Service Bulletin No. 277C

MODEL	TYPE	SECTION/GROUP	DATE
D4500 / D4505 Series Coaches	Field Change Program	12-Suspension	Feb. 24, 2009
SUBJECT TAG AXLE / DRIVESHAFT INTERFERENCE-FIXED TAG AXLE			
CONDITIONS REVISION TO 277B-ADDITIONAL UNITS INCLUDED

Service Bulletin No. 320

MODEL D4500 / D4505 Series Coaches	TYPE Field Change Program	SECTION/GROUP 14-Drive Shaft	DATE Feb. 24, 2009
SUBJECT TAG AXLE / DRIVE SHAFT INTERFERENCE – DETROIT DIESEL SERIES 60 ENGINE AND ZF TRANSMISSION			
CONDITIONS IN CONJUNCTION WITH THIS CAMPAIGN, COMPLETION OF FCP 276B AND FCP 277C IS REQUIRED ON COACHES IDENTIFIED ON THOSE FCP'S.

Figure 1.

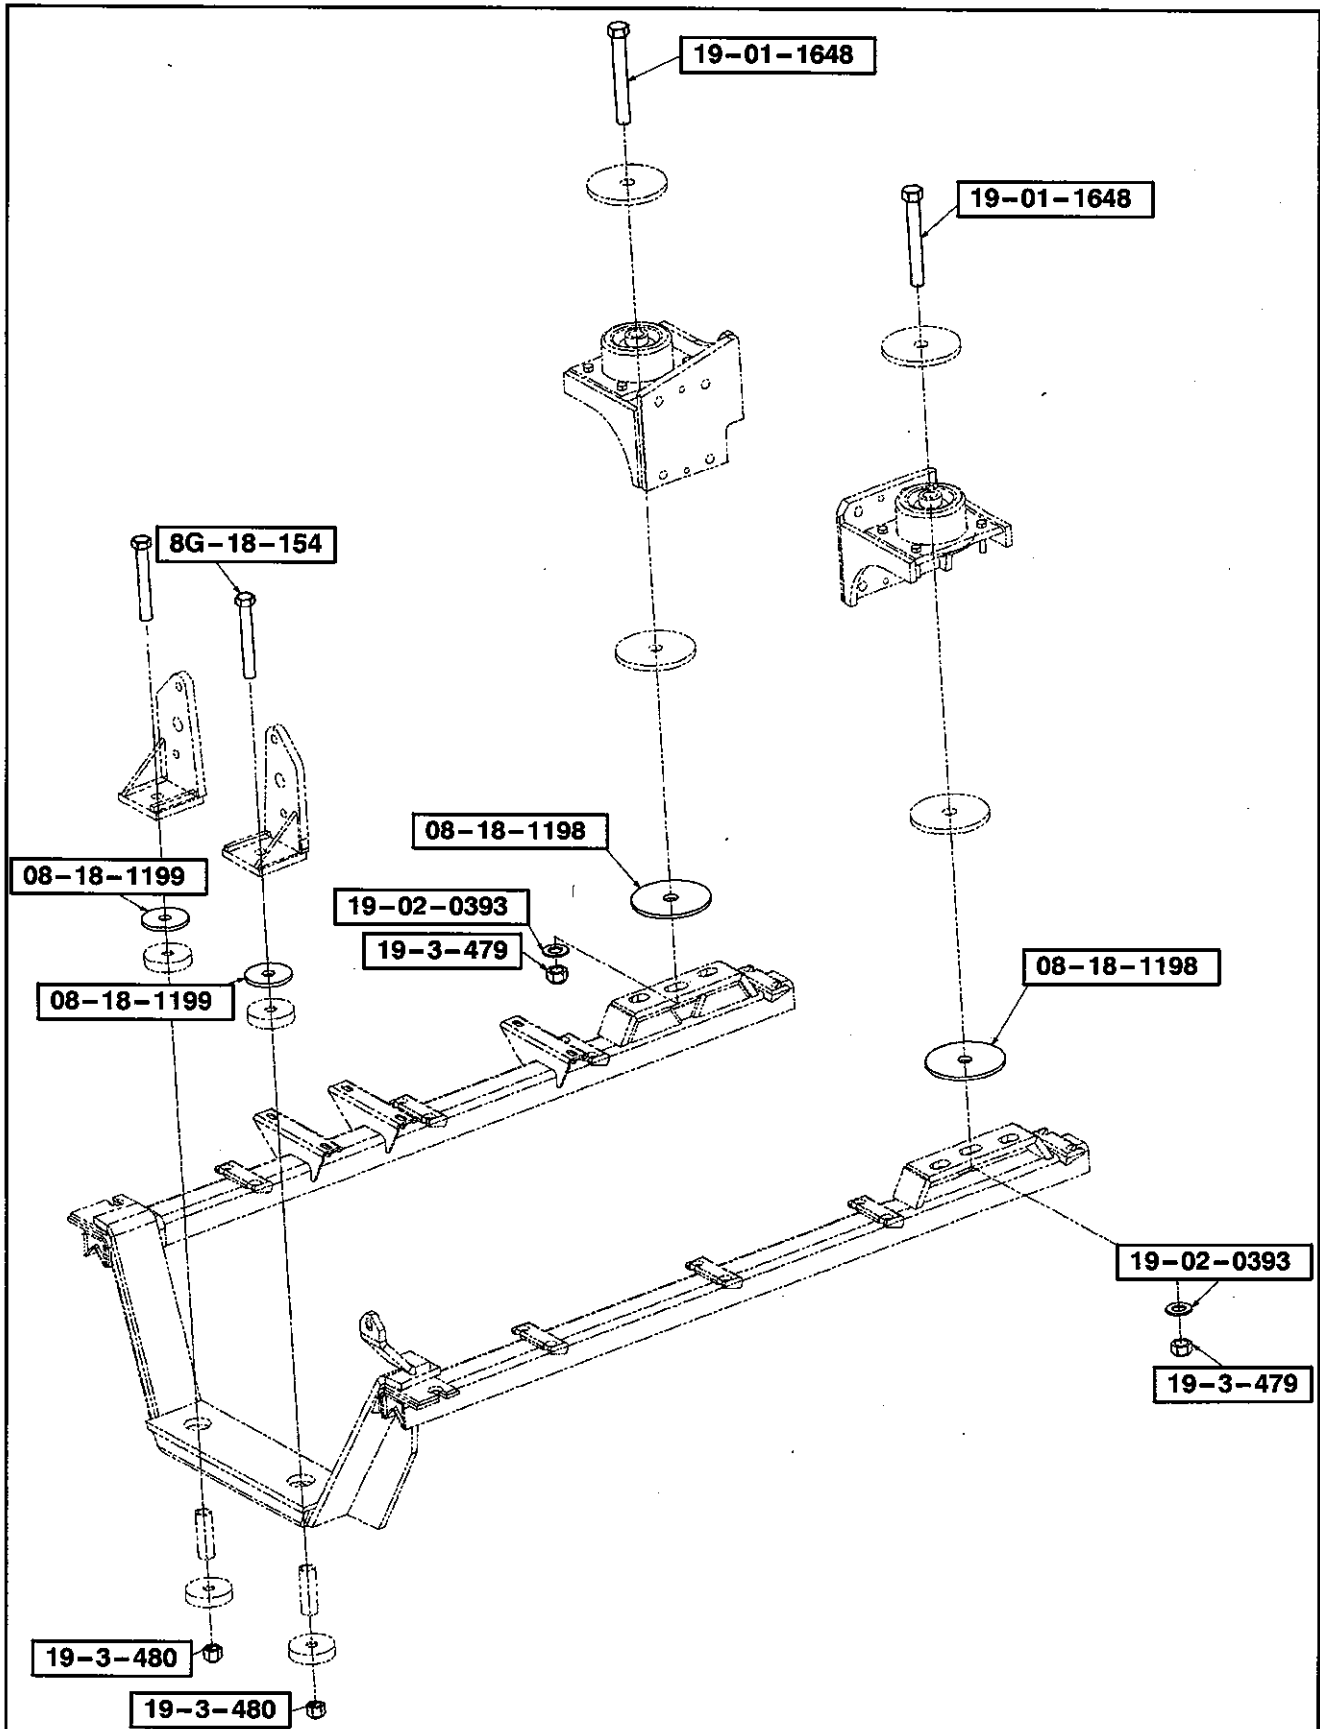
1. Turn the main battery disconnect switch to the " OFF " position. Chock both sides of the tires.
2. Open the engine compartment doors. Locate the engine remote and position the ENGINE RUN and ENGINE START to the OFF position.
3. Locate the engine cradle mounting hardware shown in Figure 1 (four locations).
4. Remove and discard the existing locknuts only from the four locations shown in Figure 1.

7. Remove and discard the existing fastener (and washer if applicable). Install appropriate shim (p/n 08-18-1198 or 08-18-1199) and new mounting hardware provided in Parts list. Tighten nut hand tight only.
8. Repeat Step 7. to next fastener.

9. Upon completion of installing the four shims and mounting hardware, lower the jack removing all stress from the engine. Remove the jack from under the coach.
10. Torque 19-3-480 to 285–385 lbs.-ft. Torque 19-3-479 to 451 –546 lbs.-ft.

Figure 3. Reference photo.

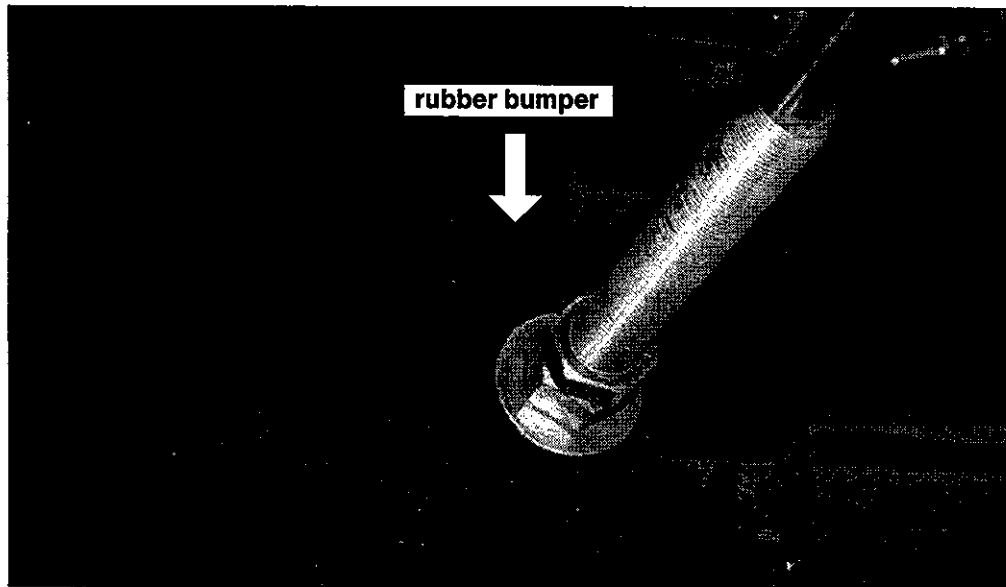
11. Locate the four existing rubber bumpers on the tag axle suspension assembly (Figures 3 and 5).

12. Remove existing bumper assembly and discard. DO NOT re-use existing bumper.

13. Disk sand the mounting surface in preparation of good reassembly.
14. Install the new rubber bumper (p/n 12G-1-5) and bumper block spacer (p/n 12R-1-6) (Detail B / Figure 5).

Figure 4. Reference photo.

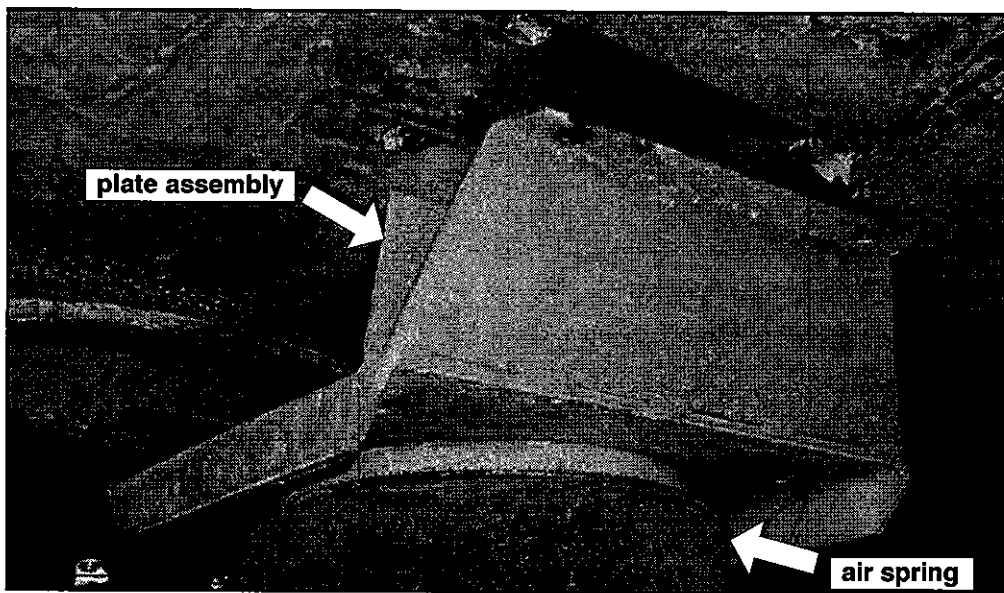
- 15. Remove and discard the plate assembly and mounting hardware (Figures 4 and 5).

Figure 5.

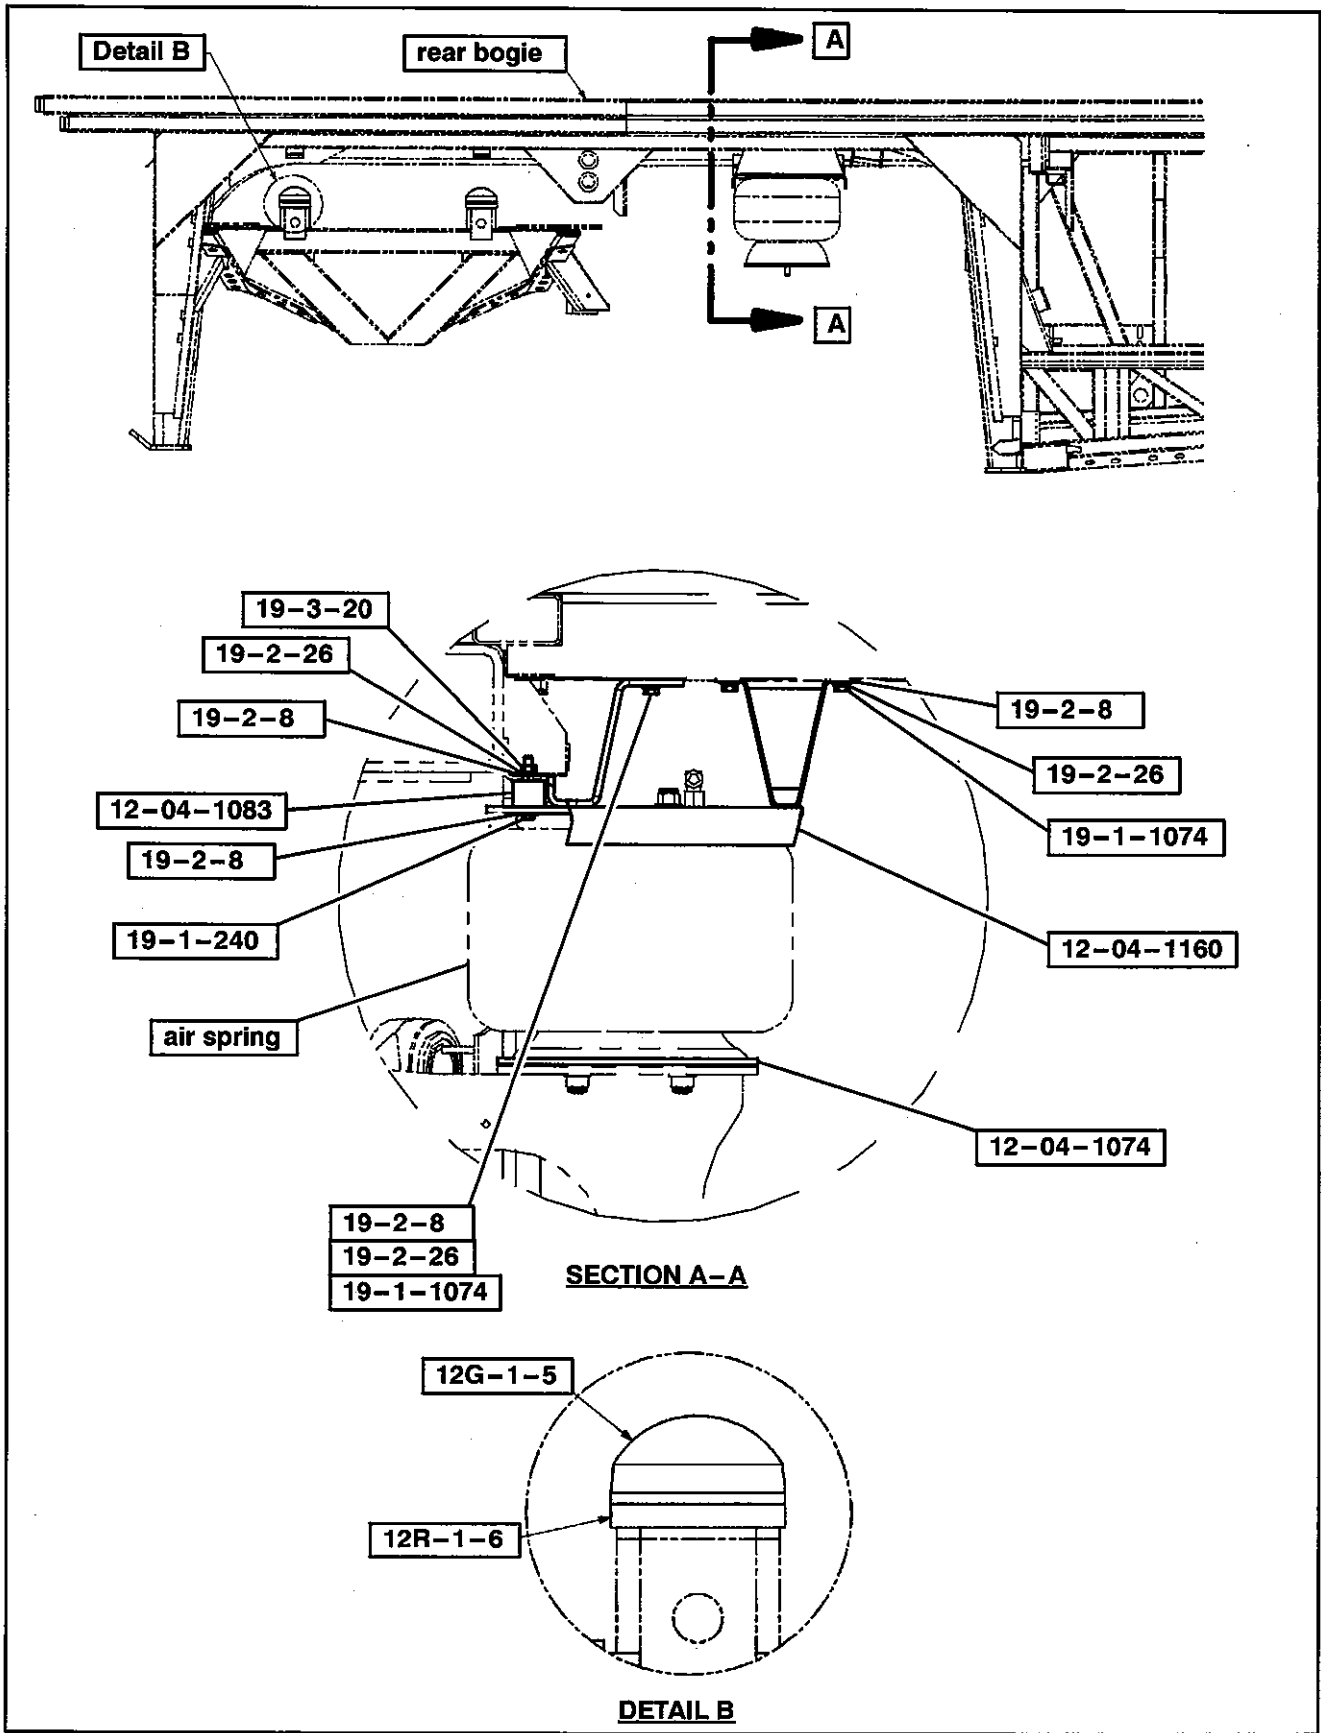
- 16. Install the new plate assembly (p/n 12-04-1160) and spacer (p/n 12-04-1083) in the locations shown in Figure 5., using the new plate assembly mounting hardware provided in the Parts list. Torque nut (p/n 19-3-314) to 18–22 ft.-lbs.
- 17. Align and position the spacer (p/n 12-04-1074) in the location shown in Figure 5.

Figure 2.

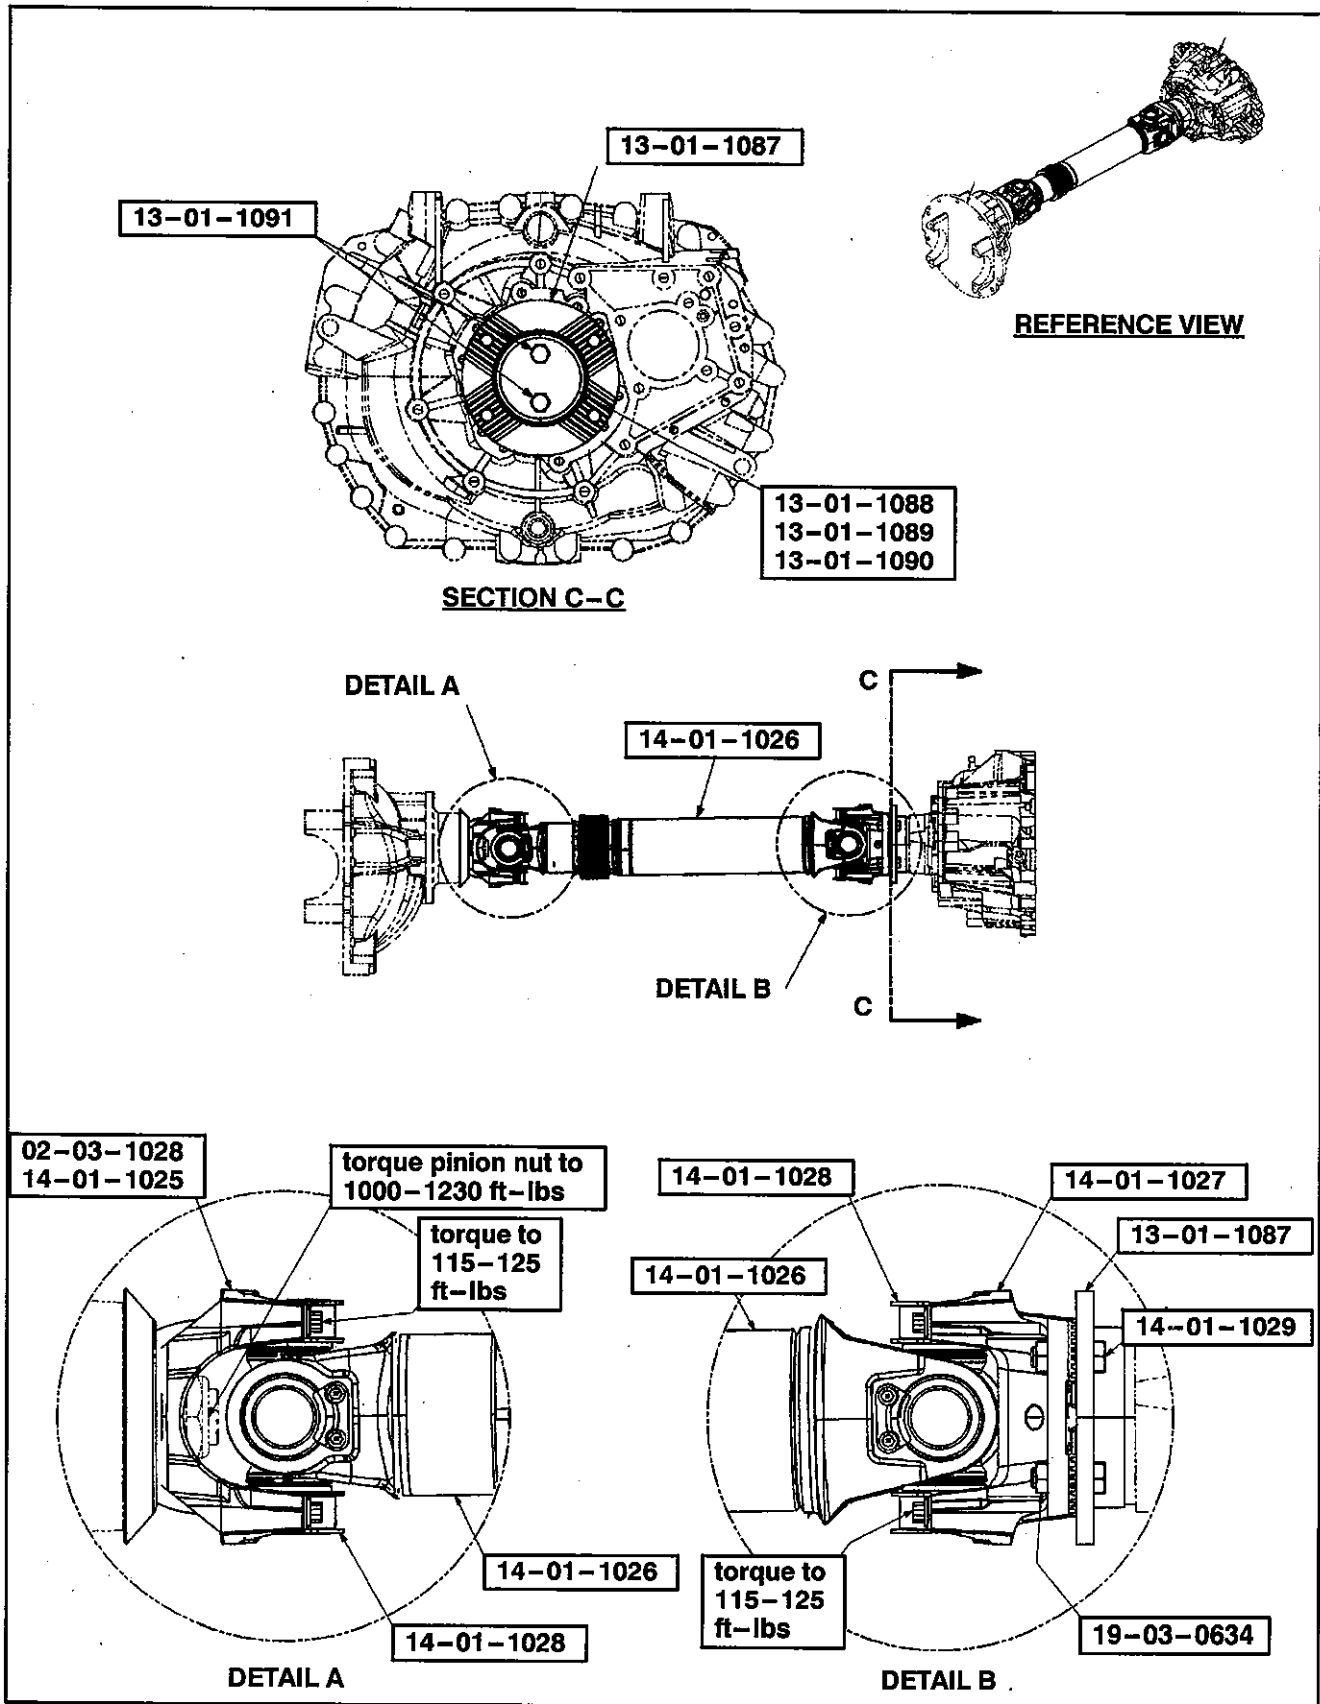
11. Using tool no. 20-710, install the drive axle pinion seal (p/n 02-03-1028) (refer to Figure 2).
12. Lubricate the seal mounting surface of the end yoke assembly (p/n 14-01-1025) and install on the output shaft taking care not to damage the seal. Install the washer and pinion nut removed in Step 10. and torque the pinion nut to 1000-1230 lb-ft.

14. Lubricate the seal contact surface on the output flange (p/n 13-01-1087) and install in transmission using plate (p/n 13-01-1091) , o-ring (p/n 13-01-1089) and bolts (p/n 13-01-1091). Apply Loctite to bolts and torque to 80-95 lb-ft.

15. Using bolts (p/n 14-01-1029) and nuts (p/n 19-03-0634), install flange yoke (p/n 14-01-1027) to output flange. Torque to 115-125 ft-lbs.

16. Using the straps and bolts kit (p/n 14-01-1028), install the driveshaft (p/n 14-01-1026) being sure to install the slip yoke end towards the drive axle. Torque the bearing cap bolts to 115 - 125 lb-ft.
17. Re-fill the drive axle with oil saved in Step 2. Top-up level as required.
18. Re-fill the transmission with fluid saved in Step 2. Top-up level as required.
19. Using grease (p/n 21-7512-5), grease driveshaft u-joint.
20. Reinstall the driveshaft guard and fasteners removed in Step 2. Torque fasteners to 16-28 lb-ft.

Figure 3. Decal, p/n 13-01-1096, used on 2007 EPA compliant coaches.

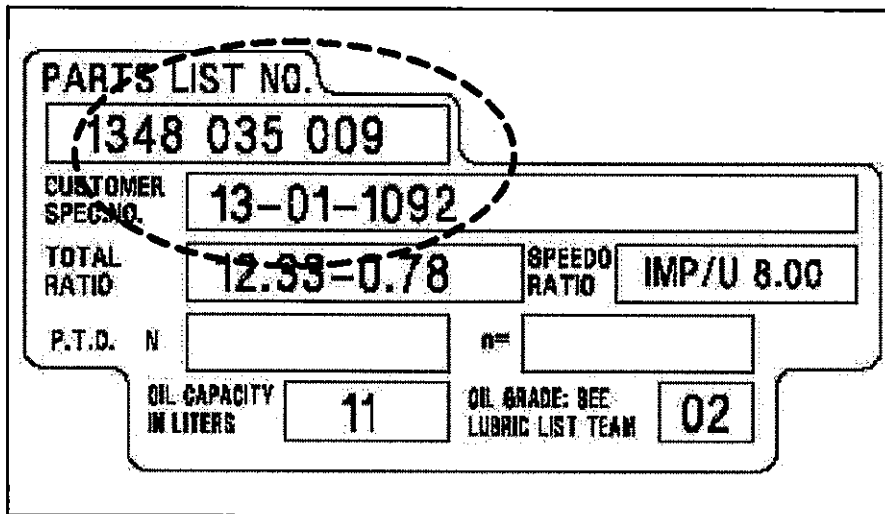
- 24. Carefully align and apply the applicable decal, p/n 13-01-1096 **or** 13-01-1097 over the existing transmission serial number plate (refer to Figure 5). Discard other decal.

Decal, p/n 13-01-1096, is applicable for unit numbers 58311–58583 (refer to Figure 3).

Figure 4. Decal, p/n 13-01-1097, used on pre-2007 coaches.

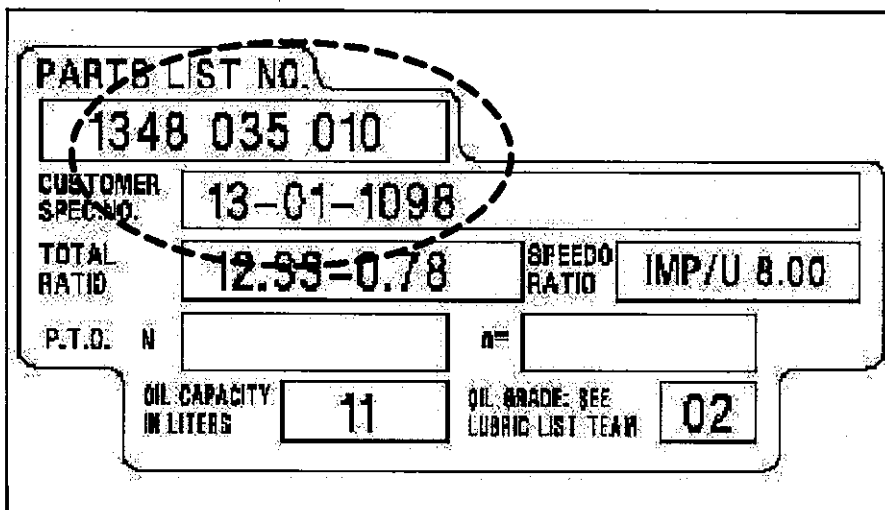
Decal, p/n 13-01-1097, is applicable for unit numbers 56555–57549 (refer to Figure 4).
